Changes to proposed District Map Amendment G-956

A revised version of DMA G-956, dated June 3, 2014, has been posted on the Planning Department website for review. It contains all of the proposed and approved changes that have occurred since May 2, 2013. The following document illustrates all of the changes to DMA G-956 since April 2014.

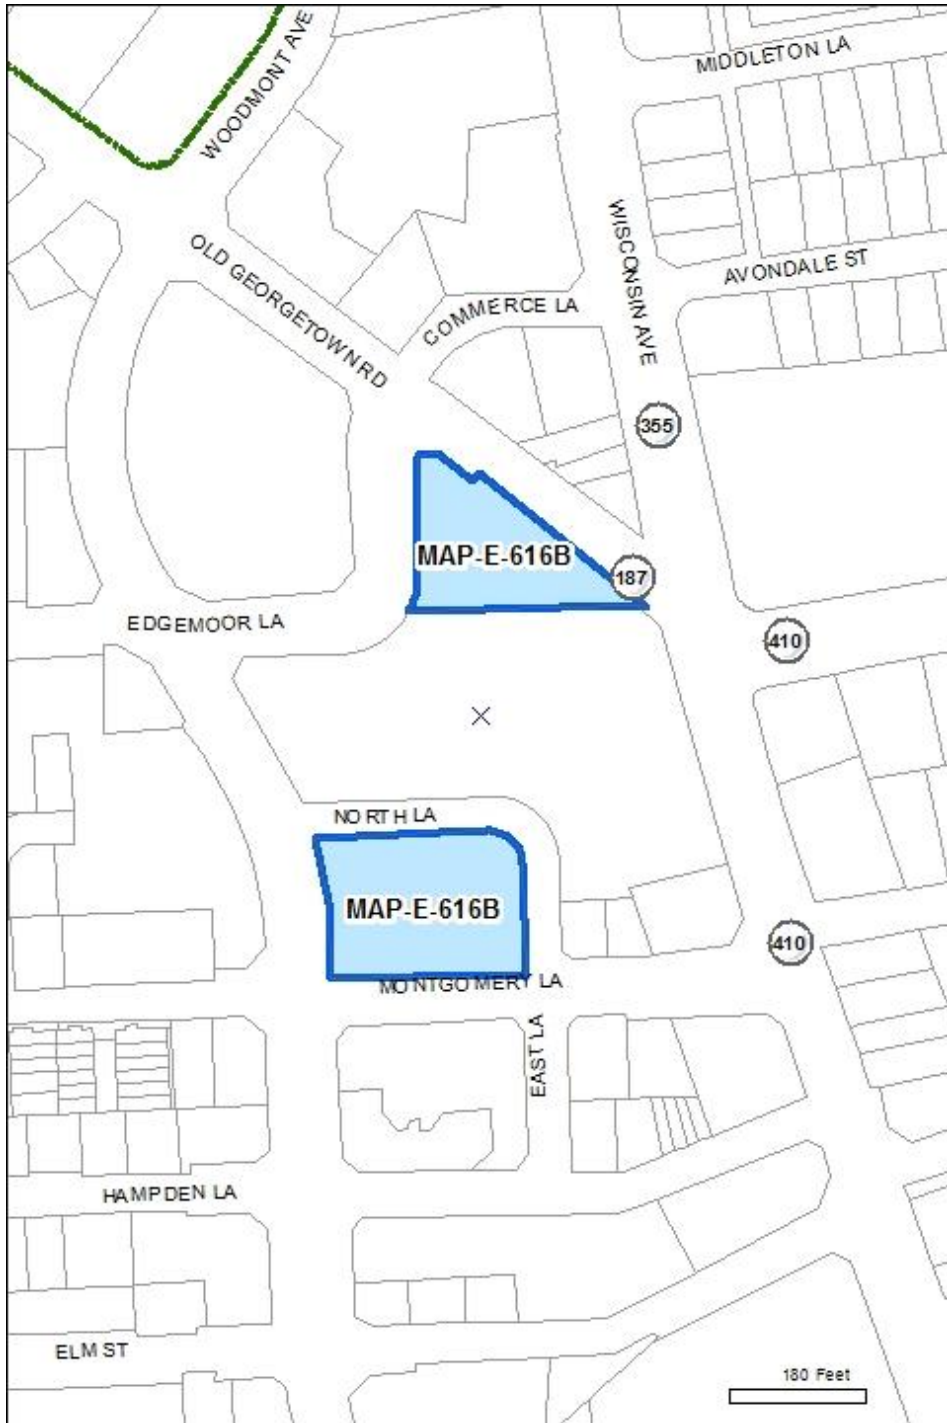
Unique ID: MAP-E-616B		staff error
Master Plan ID:		
Master Plan:	Bethesda CBD	
Location:		
Existing Zone:	CBD-3	
Proposed Conv: (4/18)	CR-8.0 C-6.0 R-6.0 H-200 T	
Prop. Revised Conv:	CR-8.0 C-6.0 R-7.5 H-200 T	
Category: Error		
Modifications	Zone Group:	No change
	Overall FAR:	No change
	Comm'l FAR:	No change
	Resid'l FAR:	Increased to 7.5
	Height:	No change
Reason for change:		
<p><i>In earlier versions of the DMA, CBD-3 was converted with 7.5 FAR of residential development. The current ordinance limits solely residential projects to 200 dwelling units per acre, however, it does not put a limit on residential density in mixed-use projects.</i></p> <p><i>After internal discussion, staff felt that the 200 dwelling units per acre limitation was a more appropriate limit, since under the CR zone it was not possible to differentiate between single-use and mixed-use projects. Therefore, staff changed the proposal to reflect a residential limit of 6.0 FAR.</i></p> <p><i>However, upon further discussion, and with input from others familiar with the zone, staff determined that reducing the FAR to 6.0 would be a significant reduction in what could actually be built, since today a project could be developed with very minimal commercial FAR and still be allowed to build almost 8.0 FAR of residential.</i></p> <p><i>Therefore, staff believes the earlier change (MAP-E-590) was in error, and is returning the CBD-3 conversion to its original CR-8.0 C-6.0 R-7.5 H-200T.</i></p>
